Agenda Item # 4

SUB-003714-2026

Parkway Commons Subdivision

APPLICATION NUMBER 4 DATE May 21, 2026

DETAIL SITE PLAN

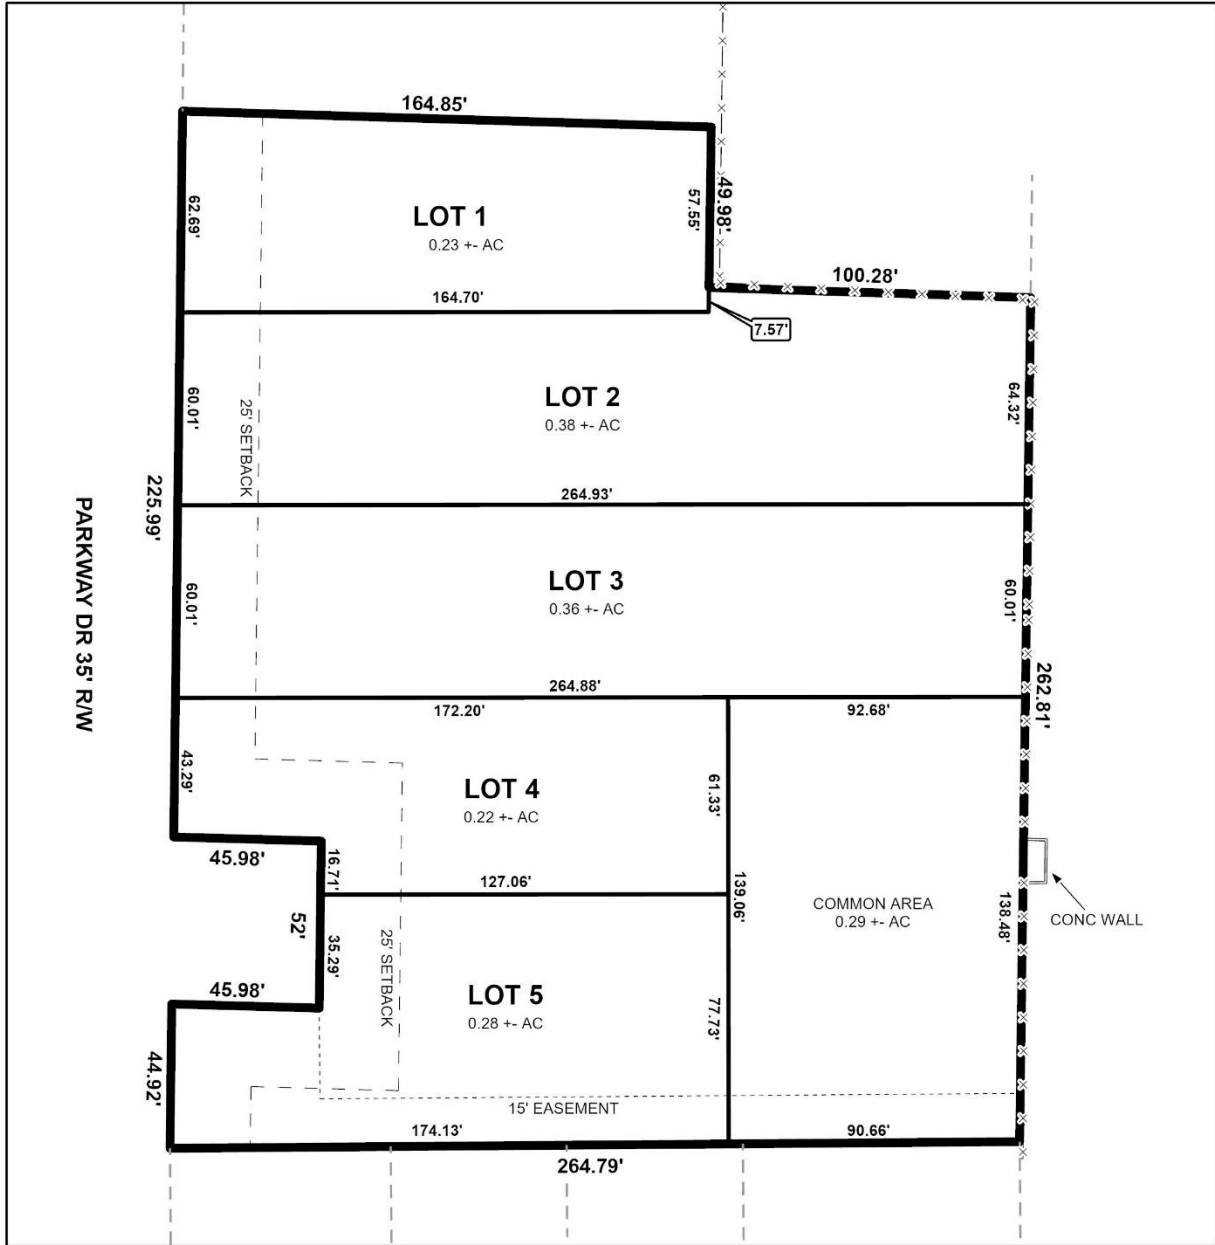
The proposed lots front Parkway Drive, a minor street without curb and gutter requiring a 60-foot-wide right-of-way at this location. The preliminary plat depicts a substandard right-of-way width; therefore, additional dedication is required. If approved, the plat should be revised to illustrate sufficient dedication to provide 30 feet from the centerline of Parkway Drive, unless a waiver of Section 6.B.9. of the Subdivision Regulations is recommended by the City Engineer and Traffic Engineer.

In addition, Parkway Drive terminates at this location and does not appear to comply with International Fire Code (IFC) standards for maneuverability on closed-end streets. Sections 6.B.3. and 6.C.9. of the Subdivision Regulations require right-of-way dedication sufficient to meet IFC standards, as determined by the City Engineer. Therefore, the Final Plat should be revised to demonstrate compliance with these requirements, unless waivers of Sections 6.B.3. and 6.B.9. are recommended by the City Engineer.

As proposed, Lots 2 and 3 exceed the maximum width-to-depth ratio of 3.5-to-1 measured at the building setback line. Therefore, approval of the request will require a waiver of Section 6.C.3. of the Subdivision Regulations.

A drainage easement is depicted along the south property line of proposed Lot 5. If approved, a note should be placed on the Final Plat stating that no structure shall be constructed within any easement without permission from the easement holder.

1. Revision of the plat to illustrate dedication sufficient to provide 30 feet from the centerline of Parkway Drive, or as approved by the City Engineer or Traffic Engineer, unless a waiver of Section 6.B.9. of the Subdivision Regulations is approved;

2. Revise the plat to illustrate a right-of-way diameter sufficient to meet the requirements of the International Fire Code (IFC), as determined by the City Engineer, in compliance with Sections 6.B.3. and 6.C.9. of the Subdivision Regulations;

5. Placement of a note on the Final Plat that maintenance of the Common Area is the responsibility of the property owners and not the City of Mobile;
6. Placement of a note on the Final Plat stating that no structure may be constructed or placed within any easement without permission from the easement holder;
